DEV25-03 **2055 Barrett Dr**, Katie Fitzjarrald of Kimley-Horn c/o HD Development of Maryland INC requests approval of a **Development Plan** to install Outdoor Storage and Sales Display areas on the Front and Rear of the building and parking lot, as well as the installation of Seasonal Sales area(s) within the parking lot, located within Greenfield Business Park Section 5 Block A, encompassing approximately +/- 9.38 acres. Zoned "CN" - Commercial North

# SITE PLAN

# HOME DEPOT STORE # 2026

### 2055 BARRETT DR

**SITE PLAN (AERIAL)**

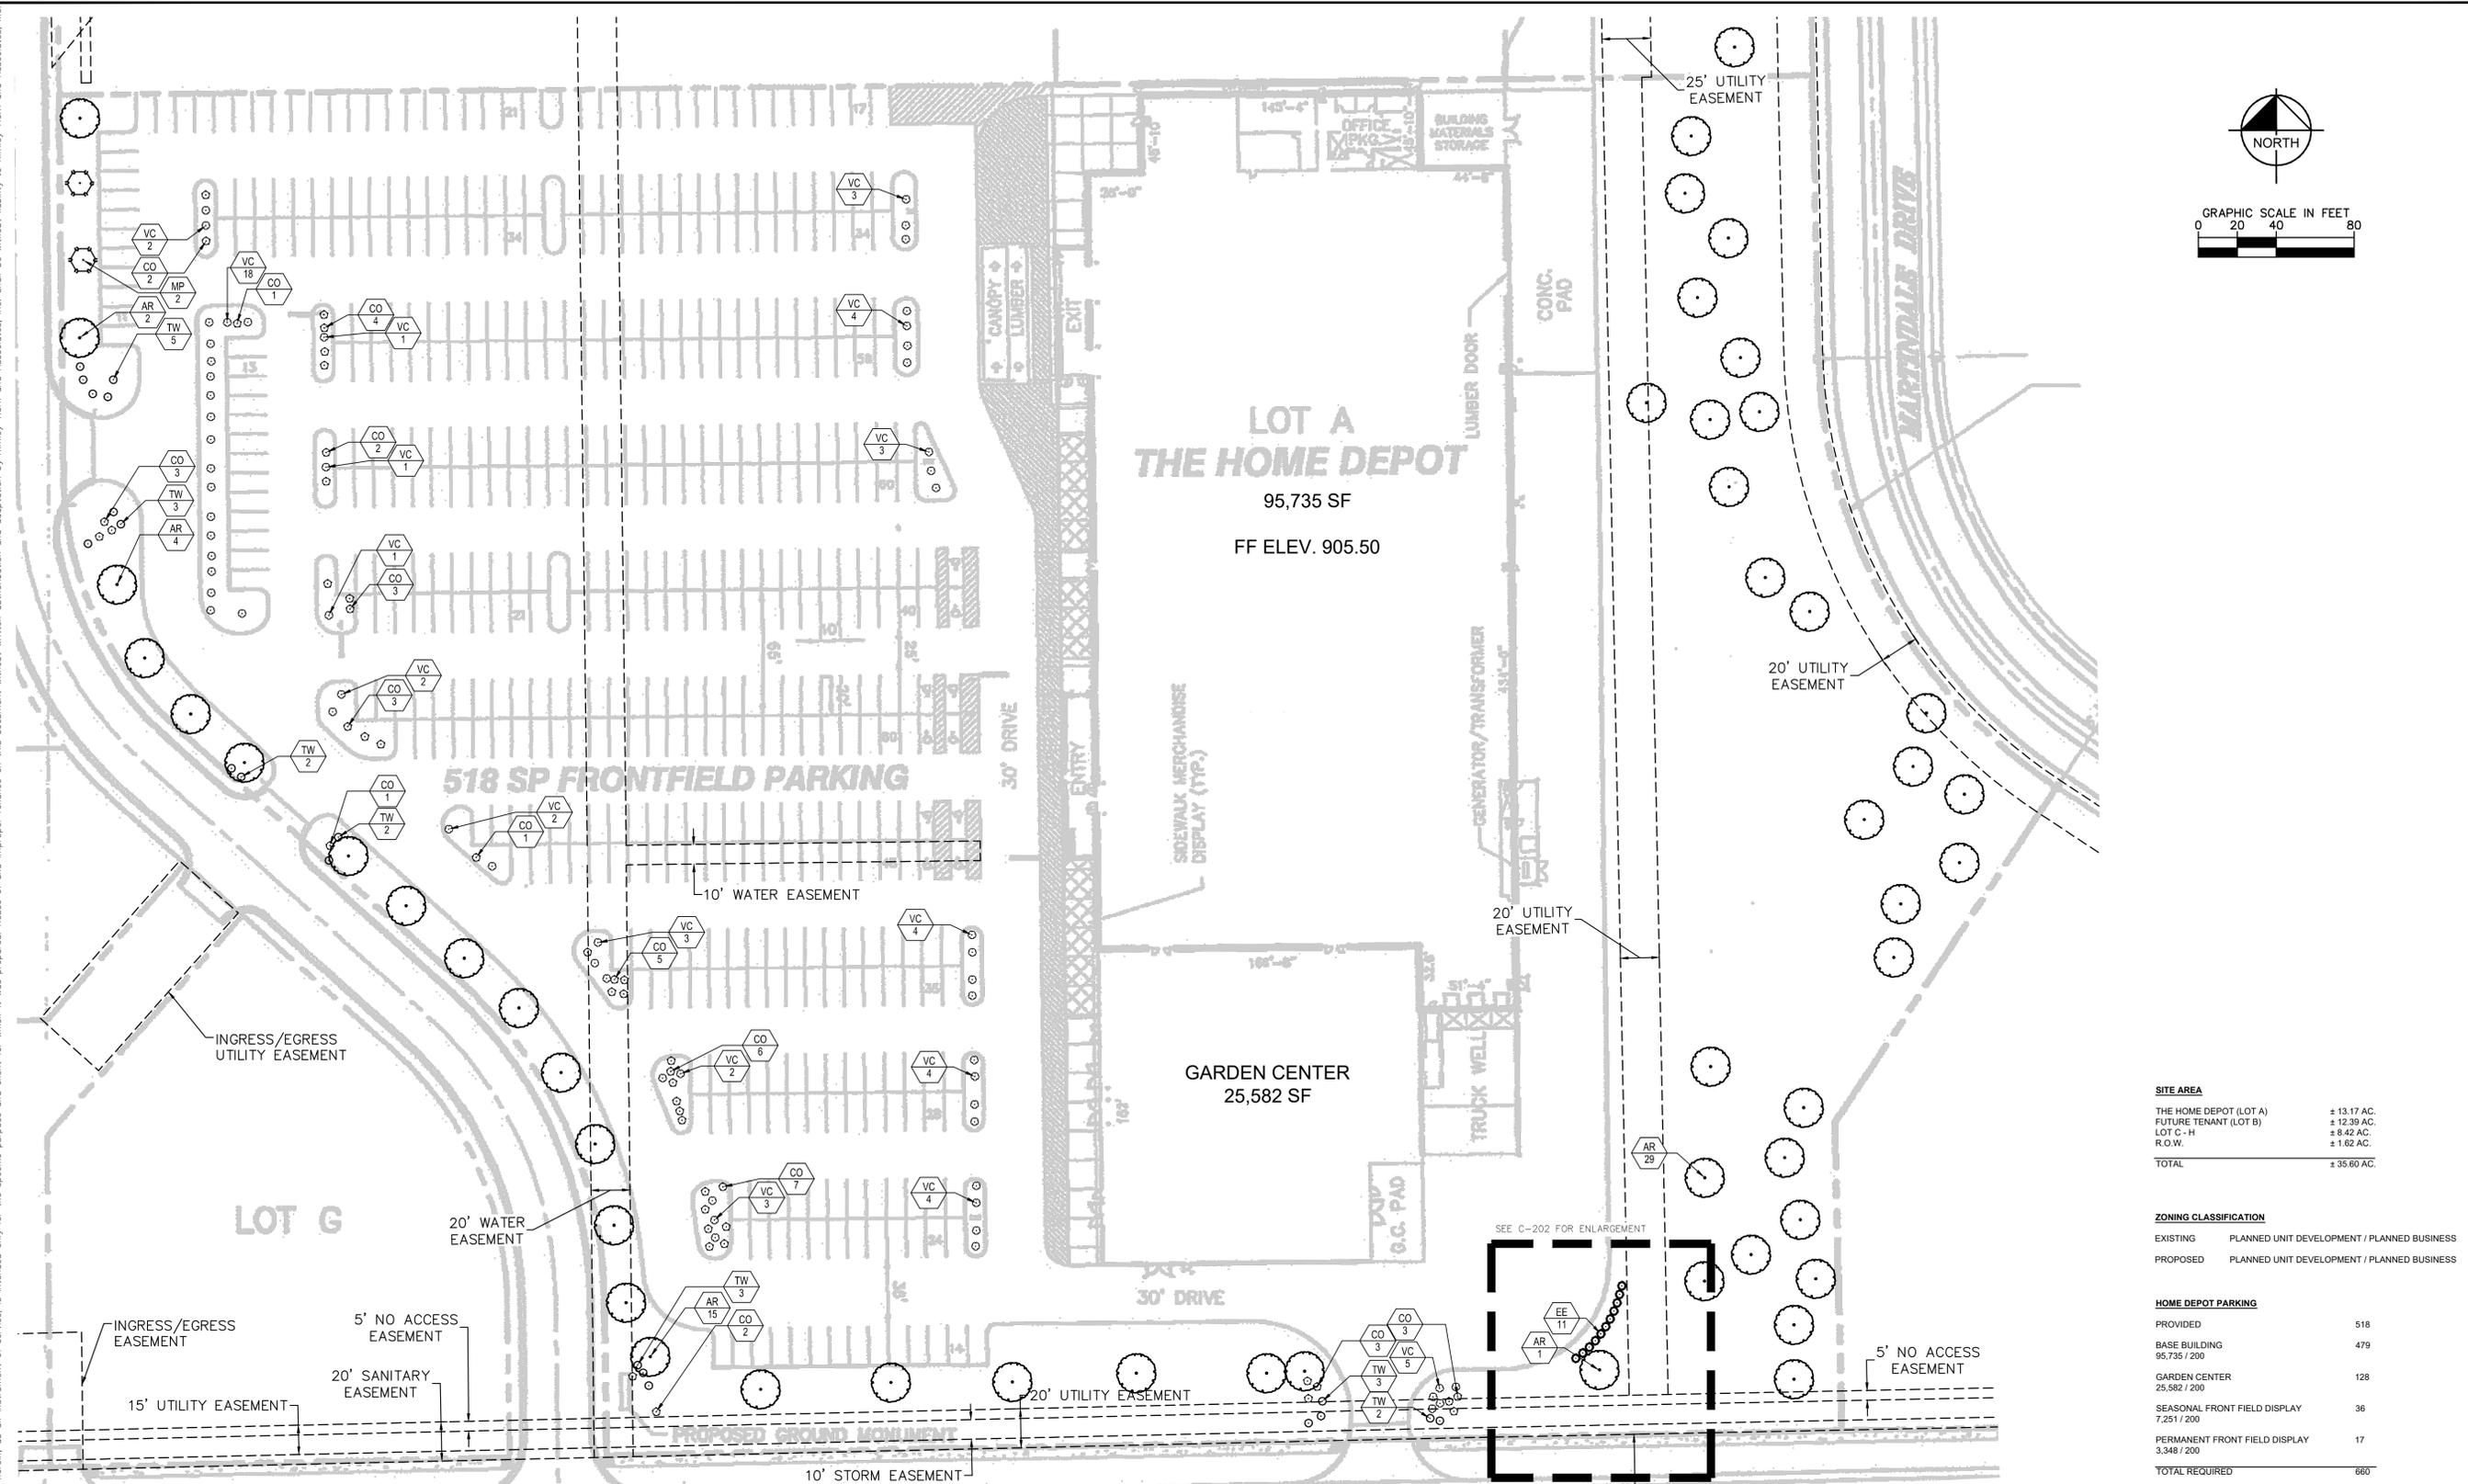
Third, there is proposed to be an installation of outdoor sales, display, and storage for "riding mowers and fence panels" along the northern boundary of the parking lot, totaling 3,438 square feet and encompassing 17 parking spaces.

Findings- Staff finds that the creation of what is effectively an off-site open-air storage and sales area is inappropriate for this property. No screening has been proposed, meaning it detracts from the neighboring properties. It has few if any security measures proposed, making it an inviting site for mischief and criminal activities. Staff finds that what is proposed here is unsupportable as presented, both generally and specifically.

Fourth and finally, there is proposed to be an official allowance for approximately 9,769 square feet of outdoor sales, display, and storage along the front façade of the building. This was denied under the previous Development Plans. The UDO allows for 1% of the Gross Floor Area of a retail location as outdoor sales and display along a front façade. The building has approximately 121,317 square feet of Gross Floor Area between the main building and the Garden Center. This would allow 1,214 square feet of sales and display along the front façade.

Findings- Staff finds that an increase of the front façade sales and display area of 8 times what is allowed is not supportable as proposed. No justification for the need for that display, sales, and storage has been provided. Staff is concerned that, similar to our comments regarding the North Parking Area, this will detract from the surrounding properties and be an invitation for mischief. Further, Staff is concerned that by allowing the entirety of a façade to be covered by storage and sales, the area could easily fall into a state of dishevelment and disrepair.

The existing parking lot has 518 parking spaces, per the Petitioner. The Seasonal sales area would remove 36 spaces, bringing that number down to 482. The northern parking area proposed to be dedicated to sales, display, and storage would remove a further 17 spaces, bringing the total parking spaces available to 465.

Findings: The UDO requires 660 parking spaces, with allowances for the Planning Director to give up to a 25% reduction to the minimum requirements. Such a reduction would put the minimum parking spaces at 495.

Staff Recommendation: Denial of Amendments #3 & 4 of the Development Plan to expand an existing retail development within Greenfield Business Park Section 5 Block A,

**Staff Recommendation: Approval of Amendments #1 & 2 of the Development Plan to expand an existing retail development** within Greenfield Business Park Section 5 Block A, subject to the findings in the staff report and the following conditions:

1. The proposed "Permanent Storage" areas as shown on the Development Plan along the front façade of the building and along the north of the parking lot (Modifications# 3 & 4) are to be denied approval and removed from the plans.

2. A revised set of Development Plans shall be submitted to and recorded by the Planning Department with the above-mentioned "Permanent Storage" areas along the front façade of the building and the north of the parking lot area removed.

**OVERALL LANDSCAPE PLAN**

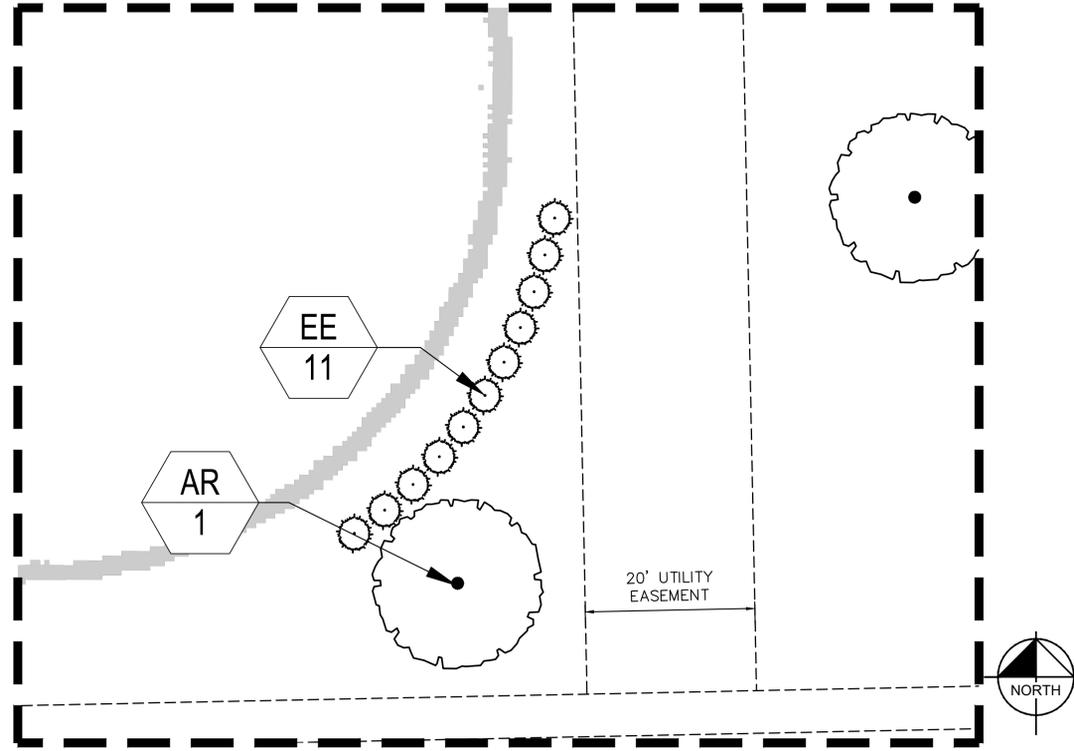
Landscaping- Increased Landscaped Screening in the form of tall and dense evergreen trees on the berm to the south east of the property has been proposed to enhance the screening between this property and the residential properties to the south and east. This screening will also buffer the view of vehicles on New Rd from the store area.

Findings: Staff finds that the increased Landscaped Screening as proposed sufficiently ensures that the residential areas to the south and east remain minimally impacted by the operations and installations on this site.
